7.0 Instrumentation and Control Systems

The information in this section of the reference ABWR DCD, including all subsections and tables, and figures, is incorporated by reference with the following departures and supplements.

STD DEP T1 3.4-1 (Figure 7.1-1, 7.1-2)

Figure 7.1-1 SSLC Self-Test System

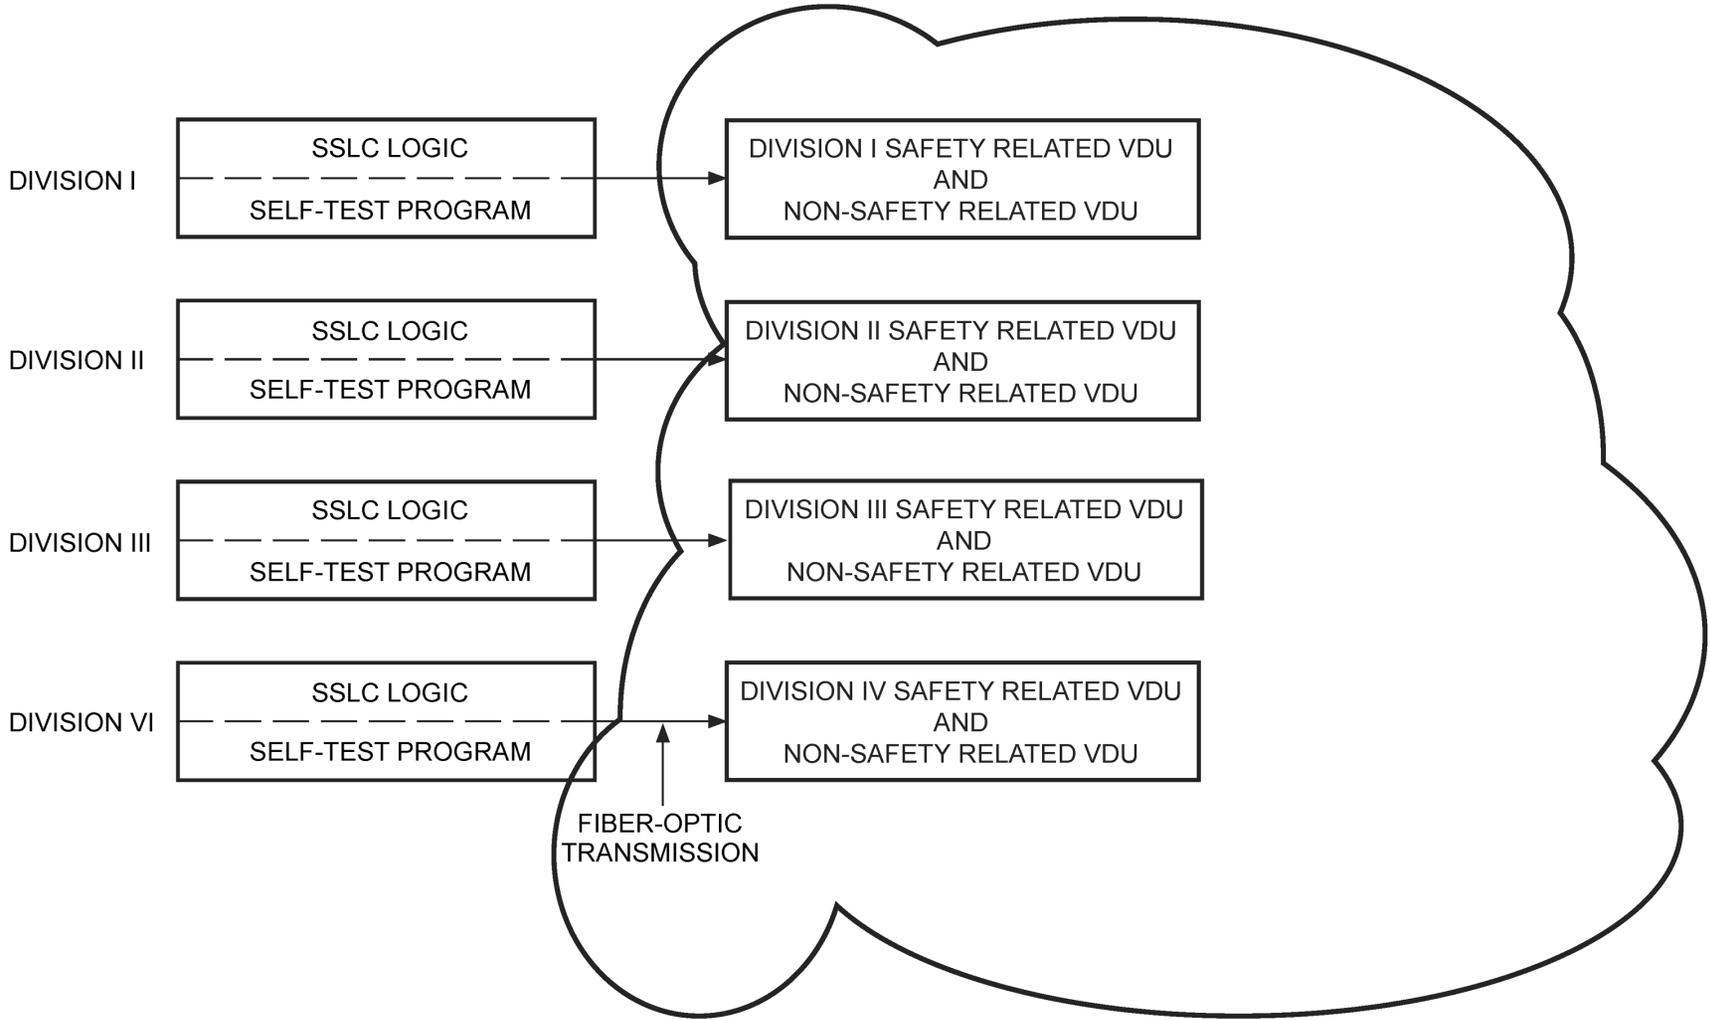
STD DEP T1 3.4-1

Divisional separation is also applied to the ~~essential multiplexing system (EMS)~~ Essential Communication Function (ECF) for Safety System Logic and Control (SSLC), which provides data highways for the sensor input to the logic units and for the logic output to the system actuators (actuated devices such as pump motors and motor-operated valves). Systems which utilize the SSLC are: (1) Reactor Protection (trip) System; (2) High Pressure Core Flooder System; (3) Residual Heat Removal System; (4) Automatic Depressurization System; (5) Leak Detection and Isolation System; (6) Suppression Pool Monitoring System; and (7) Reactor Core Isolation Cooling System. The equipment arrangement for these systems and other supporting systems is shown in Figure 7.1-2.
